Attachment A  
Section 92 Response,  
parts 1, 2, 3

**Te Tupu Ngātahi**  
Supporting Growth  
PO Box 105218  
Auckland 1143

## Attachment A: Section 92 response

Table 1: Proposed Flood Hazard Condition – changes since lodgement and rationale

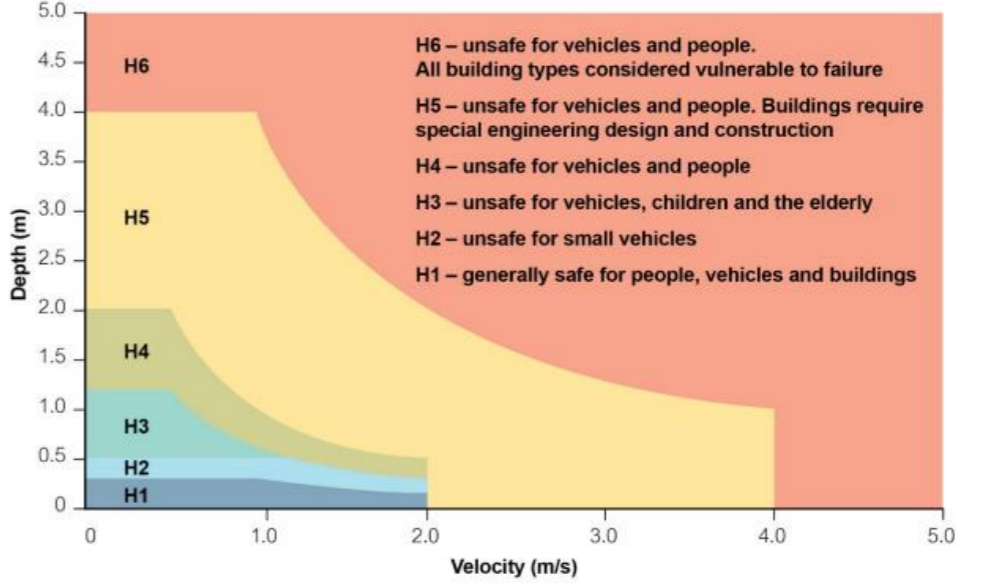
Condition as lodged Sept 2023 (Appendix B, condition 10)	Proposed change to condition	Rationale for change from conditions as lodged
(a) The Project shall be designed to achieve the following flood risk outcomes:	The Project shall be designed to achieve the following flood risk outcomes:	N/A
<ul style="list-style-type: none"> <li>i. no increase in flood levels in a 1% AEP event for existing authorised habitable floors that are already subject to flooding or have a freeboard less than 150mm;</li> </ul>	<ul style="list-style-type: none"> <li>no increase in flood levels in a 1% AEP event for existing authorised habitable floors that are already subject to flooding or have a freeboard less than <del>150mm</del>500mm;</li> </ul>	<p>A site assessment was carried out to estimate the amount of freeboard at buildings that might be affected by flooding close to the proposed NoR boundary (refer Section 4 and the maps in Appendix 1 of the Supplementary Flood Hazard Assessment). When the freeboard was estimated, the majority of those existing floors assessed were either flooded or within 150mm of flooding. Changing to 500mm had a minor increase in the number of floors subject to this condition but the controlling criteria was typically the building with freeboard less than 150mm.</p> <p>The new criteria also provides better protection for relatively new buildings that may be constructed prior to lodgement of the OPW– which is relevant to NoRs near flooding within the Future Urban Zone.</p> <p>Increasing freeboard to 500mm for these types of buildings aligns with freeboard standards in the AC Stormwater Code of Practice for new builds.</p> <p>It is not intended to protect all future buildings – those constructed after the OPW are lodged are expected to set appropriate freeboard above the Post project flood level.</p>

<ul style="list-style-type: none"> <li>ii. no more than a 10% reduction in freeboard in a 1% AEP event for existing authorised habitable floors with a freeboard over 150mm;</li> </ul>	<ul style="list-style-type: none"> <li><del>no more than a 10% reduction in freeboard in a 1% AEP event for existing authorised habitable floors to maintain a minimum with a freeboard of over 150mm;</del></li> </ul>	<p>A percentage freeboard reduction is not needed if a freeboard of 500mm is utilised in criteria i.</p>

Condition as lodged Sept 2023 (Appendix B, condition 10)	Proposed change to condition	Rationale for change from conditions as lodged
<p>iii. no increase in 1% AEP flood levels for existing authorised community, commercial and industrial building floors that are already subject to flooding;</p>	<p>no increase in 1% AEP flood levels for existing authorised community, commercial, industrial and network utility building floors that are already subject to flooding or have a freeboard of less than 300mm;</p>	<p>This criterion has been introduced to address flood effects as these types of building are present in the Project area – such as east of SH1 (NoR4).</p> <p>Increasing the freeboard to 300mm for these types of buildings aligns with freeboard standards in the AC Stormwater Code of Practice for new builds.</p> <p>Given the potential town centre areas in the Future Urban Zone there is potential for more of them to be constructed prior to the lodgement of the OPW. The new criteria provides better protection for relatively new buildings.</p>

<p>vi. no new flood prone areas;</p>	<p>no new flood prone areas; and</p>	<p>No change.</p>
<p>vii. no more than a 10% average increase of flood hazard (defined as flow depth times velocity) for main access to authorised habitable dwellings existing at time the Outline Plan is submitted. The assessment shall be undertaken for the 1% AEP rainfall event.</p>	<p>No increase of flood hazard for main vehicle access to authorised habitable dwellings existing at time the Outline Plan is submitted. The assessment shall be undertaken for the 1% AEP rainfall event. Where Flood Hazard is:</p> <ul style="list-style-type: none"> <li>• Velocity x depth &gt;= 0.6 or</li> <li>• depth &gt; 0.5m, or</li> <li>• velocity &gt;2m/s.</li> </ul> <p><del>no more than a 10% average increase of flood hazard (defined as flow depth times velocity) for main access to authorised habitable dwellings existing at time the Outline Plan is submitted. The assessment shall be undertaken for the 1% AEP rainfall event.</del></p>	<p>The wording has been changed to reflect the change from category H2 to H3 in the Australian Institute of Disaster Resilience 2017, Handbook 7, Managing the Floodplain. Using categories of protection, allows some changes to depth or velocity within category 2 while providing appropriate protection.</p> <p>The protection of both pedestrians and small vehicles are covered within category H2.</p>
